BROUSSARD'S SUBDIVISION

Engineering Comments: FINAL PLAT COMMENTS (should be addressed prior to submitting the FINAL PLAT for review and/or signature by the City Engineer):

The preliminary plat illustrates the proposed 1-lot, 0.6± acre subdivision which is located on the North side of Cottage Hill Road, 100'± East of Wyoming Drive West, within Council District 5. The applicant states that the subdivision is served by city water and sanitary sewer systems. The purpose of this application is to create one (1) legal lot of record from one (1) existing metes-and-bounds parcel.

DETAIL SITE PLAN

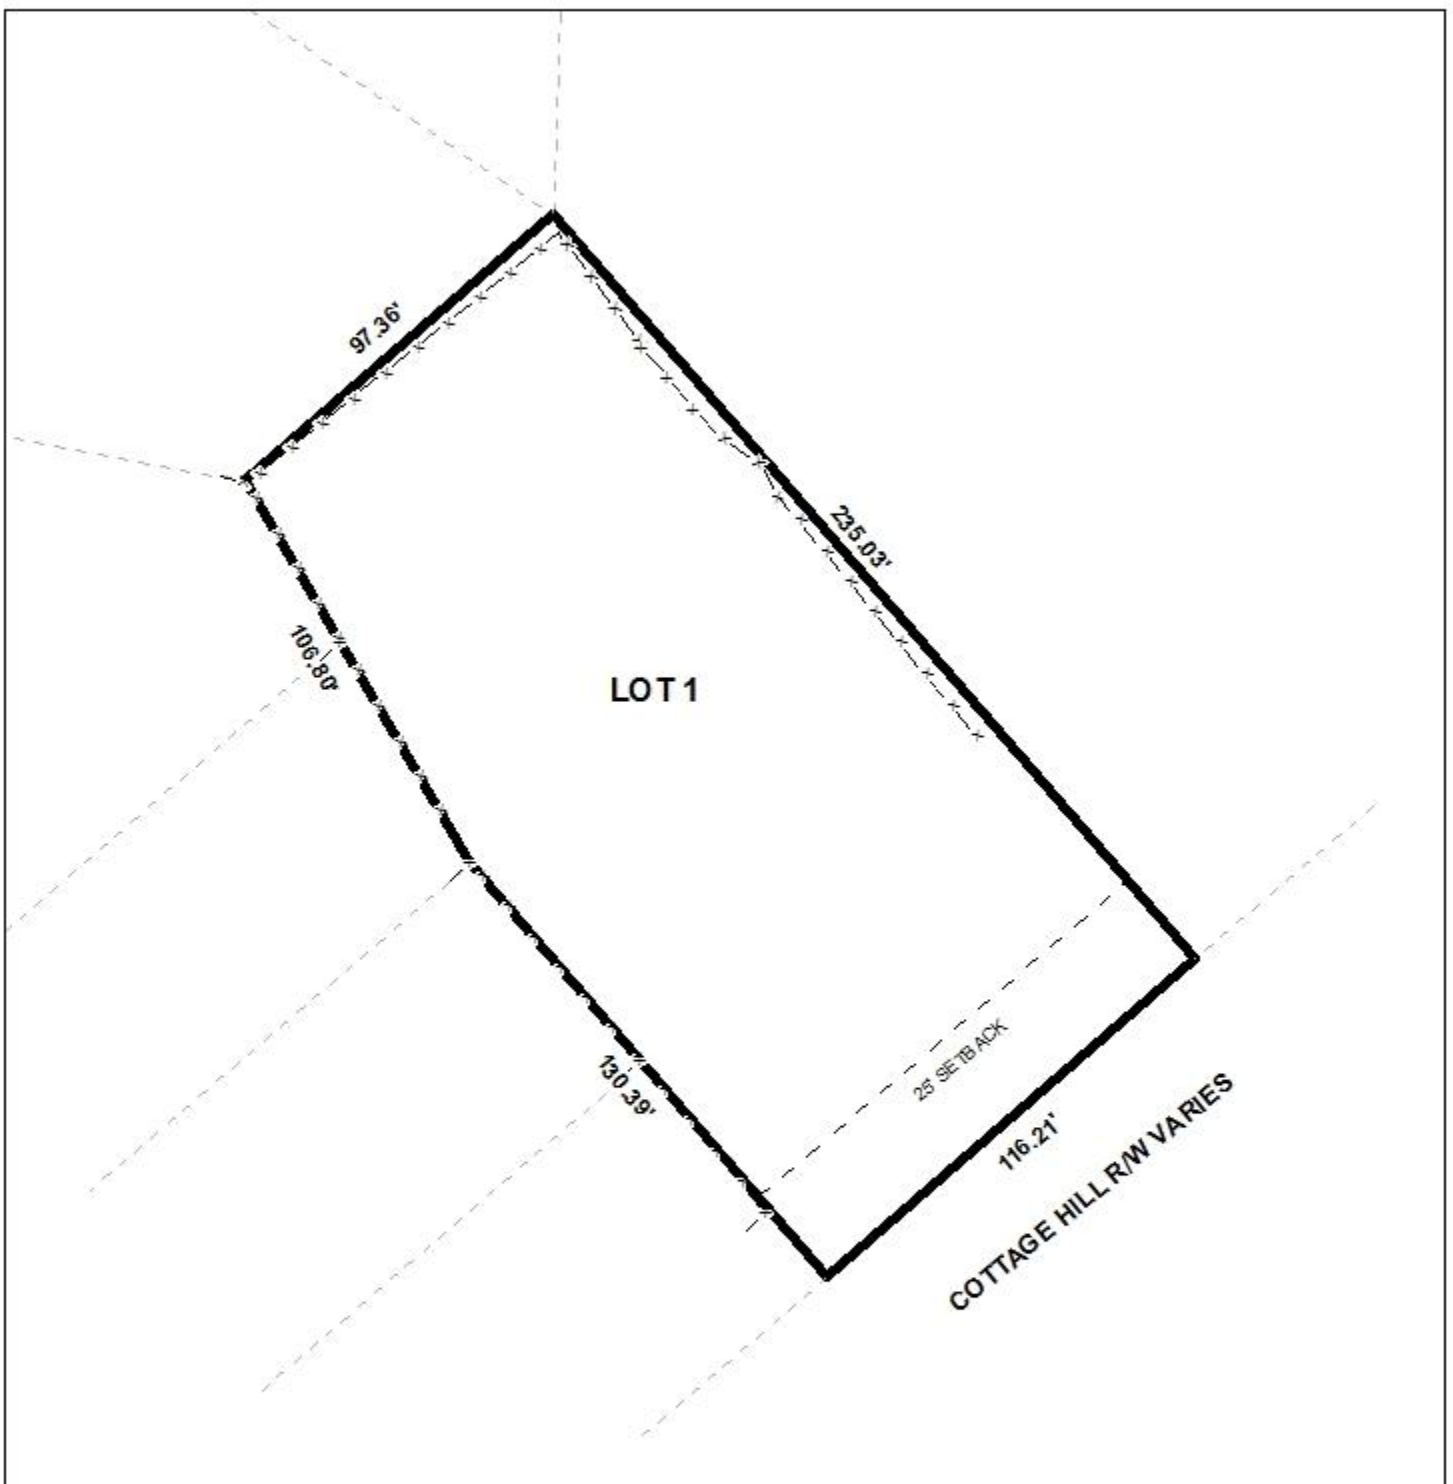
- B. Show/label the existing ROW width of Cottage Hill Rd. at the front property line.
- C. Provide the Surveyor's and Owner's (notarized) signatures.
- D. Add a note to the SUBDIVISION PLAT stating that as shown on the 1984 aerial photo (FLIGHT 24 - #79) LOT 1 will receive historical credit of existing (1984) impervious area towards stormwater detention requirement per Mobile City Code, Chapter 17, Storm Water Management and Flood Control) as follows: LOT 1 – 8,000 sf.

The site has frontage on Cottage Hill Road, which has curb and gutter and is not a major street in this area. The preliminary plat does not provide the right-of-way width along the site frontage. Therefore, the plat should be revised to indicate that the right-of-way width is at least 50' along the frontage, or dedication should be required to provide at least 25' from the centerline of Cottage Hill Road. The 25' minimum building setback line should be retained on the Final Plat, but revised to be measured from any frontage dedication, if required.

The proposed lot meets the minimum size requirements of the Subdivision Regulations. As on the preliminary plat, the lot size label in both square feet and acres should be retained on the Final Plat, revised for any required frontage dedication, or a table should be furnished on the Final Plat providing the same information.

- 1) revision of the plat to either depict a minimum existing 50' wide right-of-way for Cottage Hill Road or dedication to provide 25' from the centerline;

- 2) retention of the 25' minimum building setback line on the Final Plat, adjusted for dedication, if necessary;
- 3) retention of the lot size label in both square feet and acres on the Final Plat, revised for any required frontage dedication, or the furnishing of a table on the Final Plat providing the same information;
